**ADDENDUM
(AD)**

PROJECT: **Concrete Industries**
Break Room and Locker Room Improvements
Lincoln, Nebraska

AD NO.: 2

DATE: December 12, 2024

SHEET NUMBER
S-102

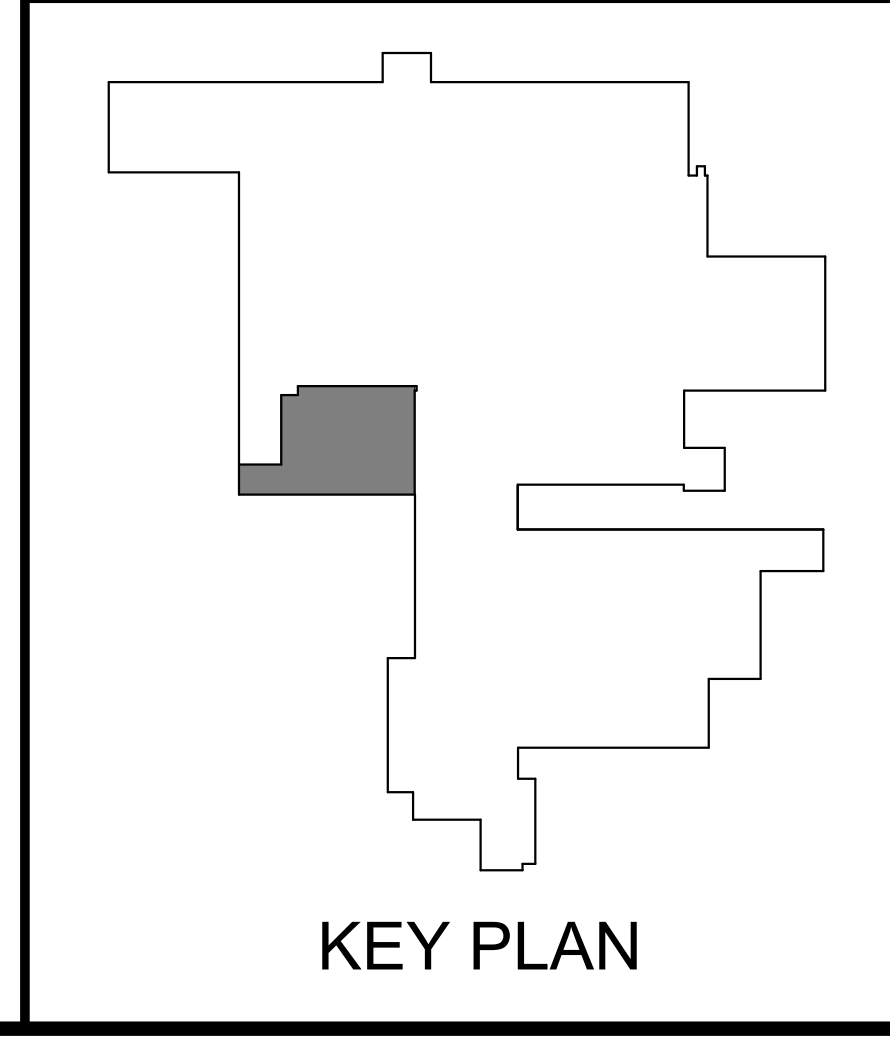
In reference to Sheet S-102, see attached revised sheet adding saddle and detail reference 10b/S-501 to support existing hollowcore at 6'-0" (1-1/2 panels) opening at existing precast wall panels.

SHEET NUMBER
AD-101

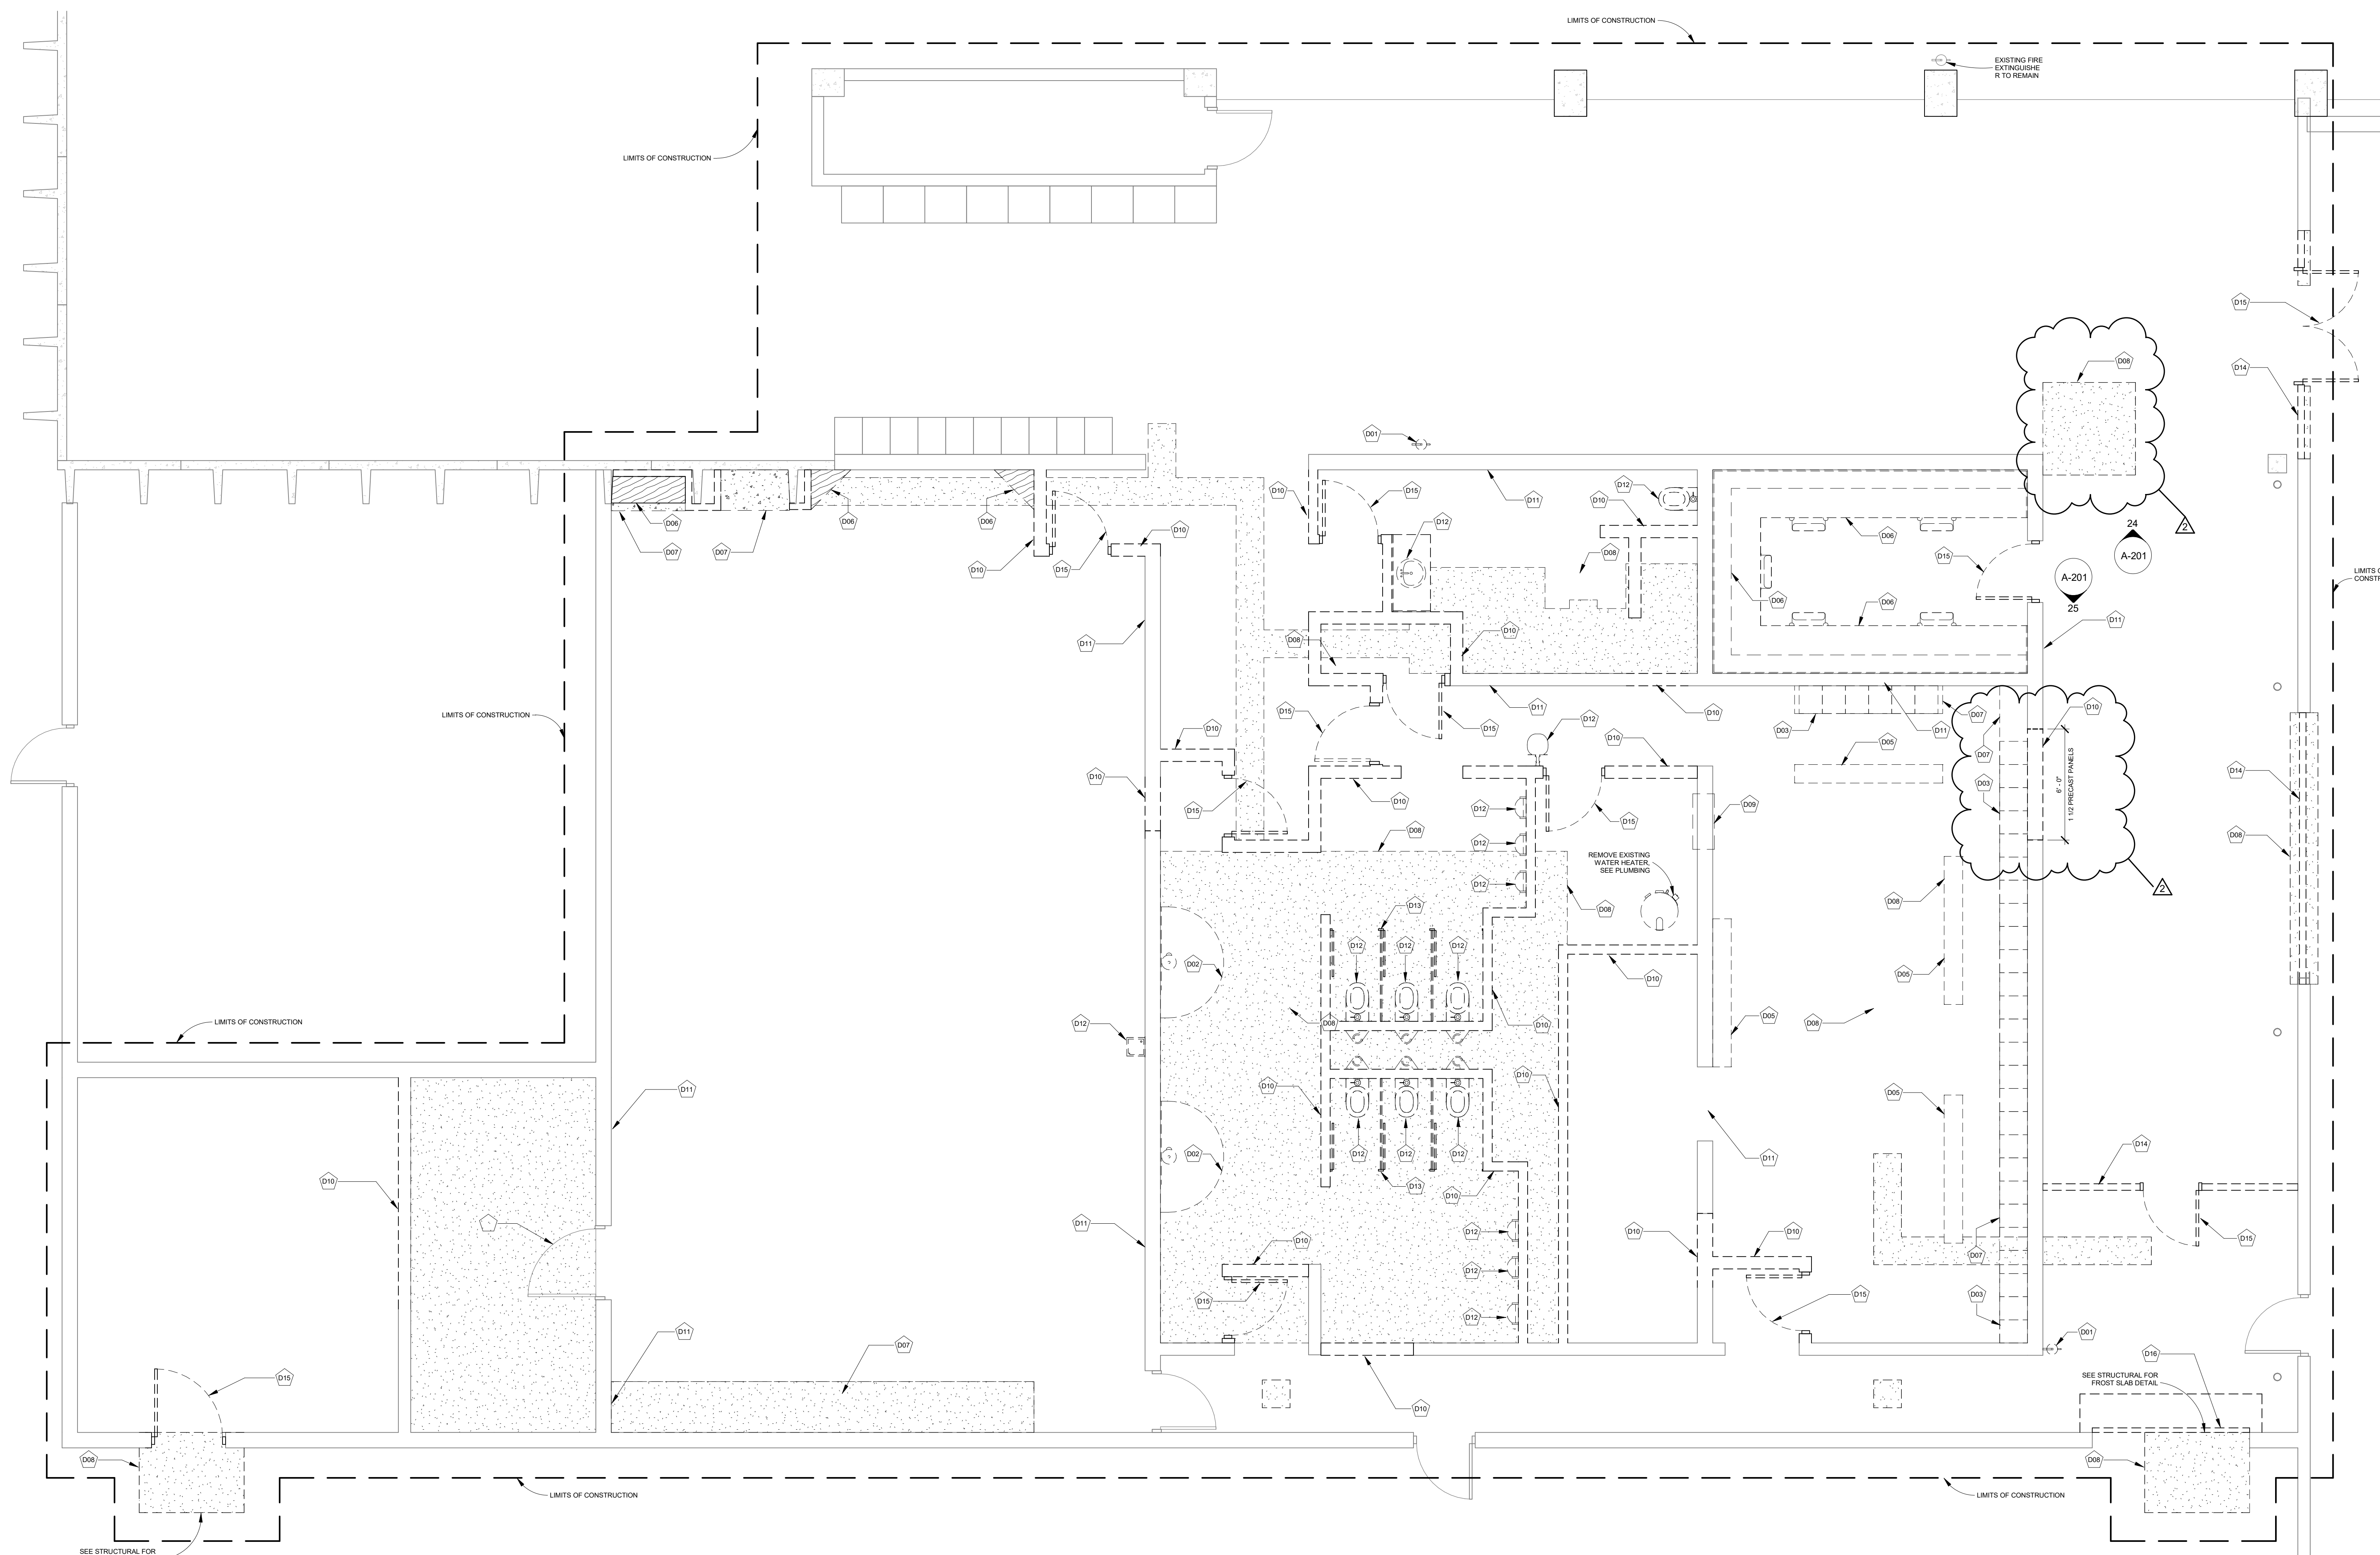
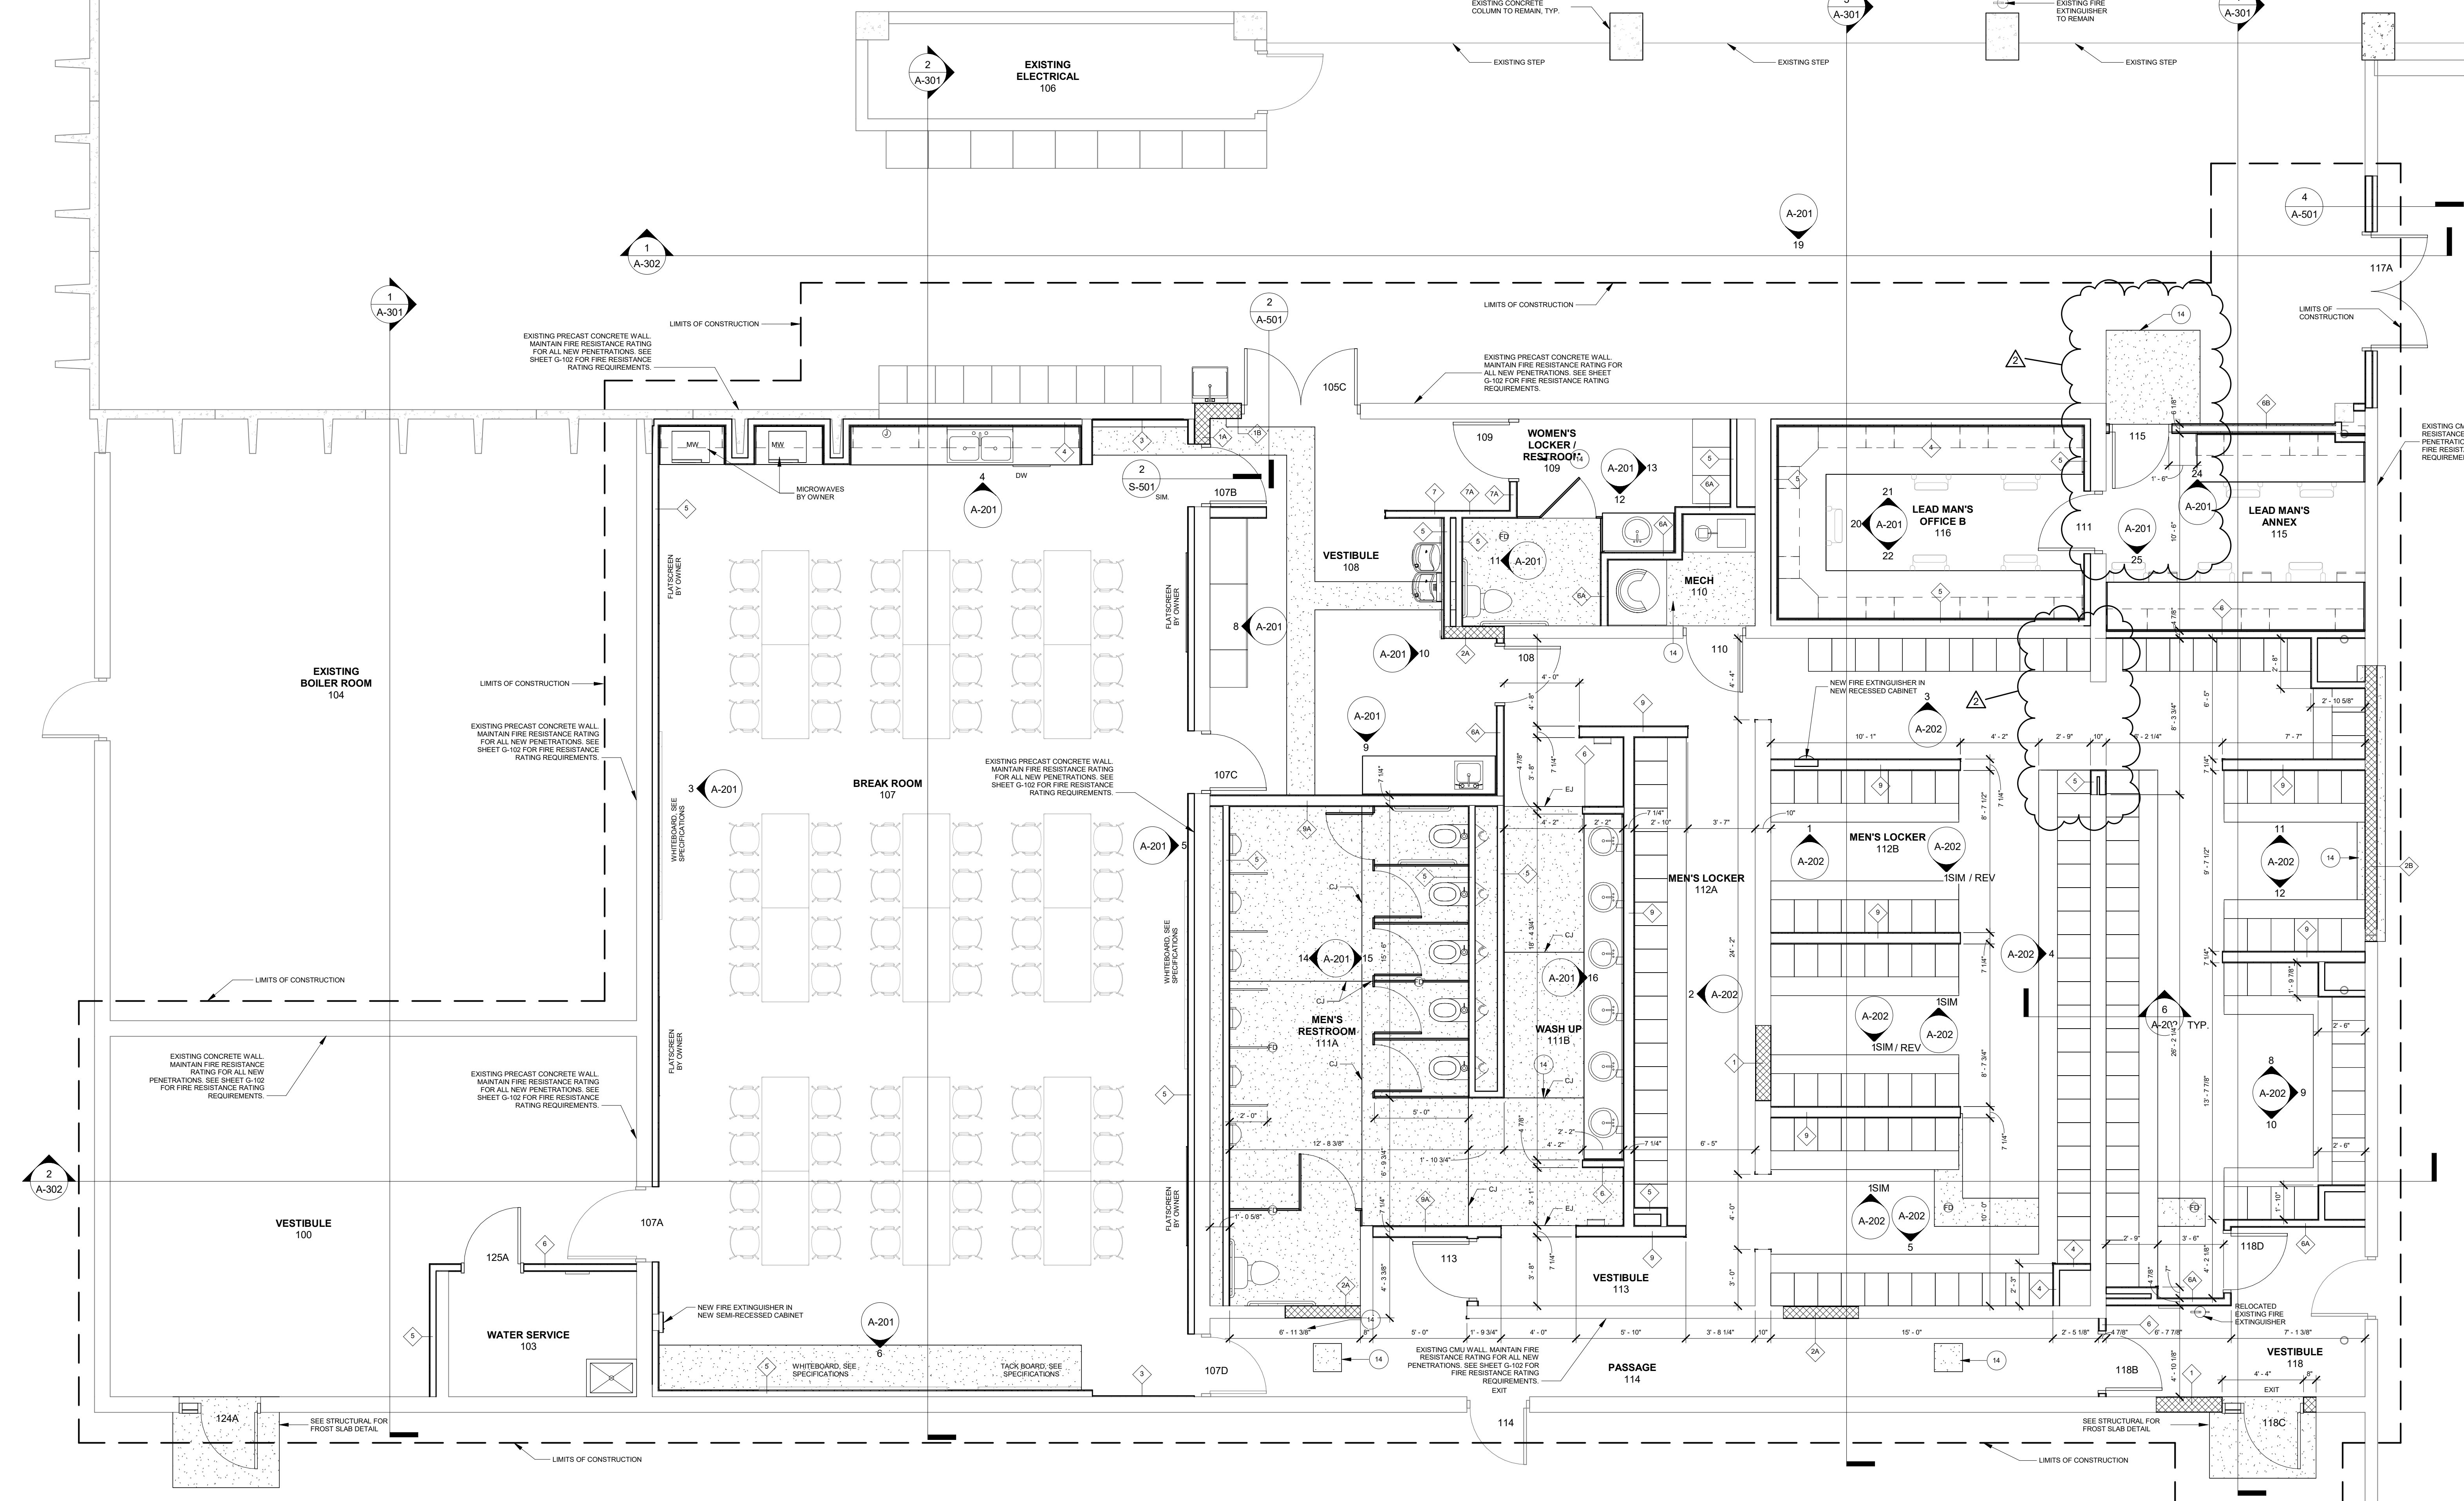
In reference to Sheet AD-101, see attached revised sheet adjusting location for demolition of 1-½ existing precast wall panels. Additional concrete slab removal has been added. The anticipated concrete slab depth has been changed from 8" to 12".

SHEET NUMBER
A-101

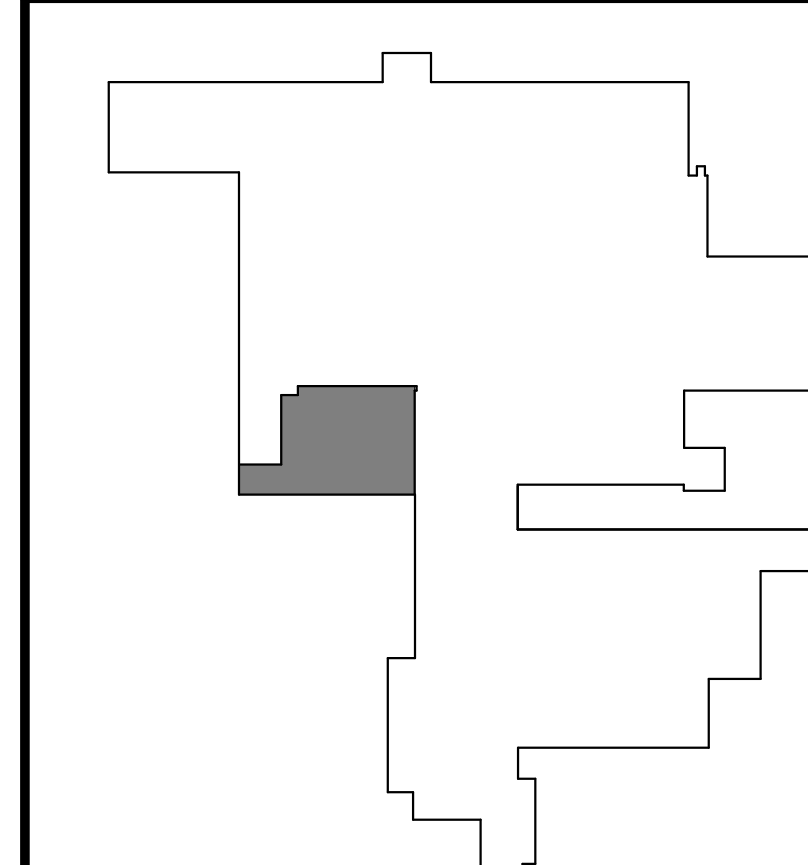
In reference to Sheet A-101, see attached revised sheet adjusting location for opening at existing precast wall panels. Steel stud infill added. Additional new concrete has been added north of the door to Lead Man's Annex 115.
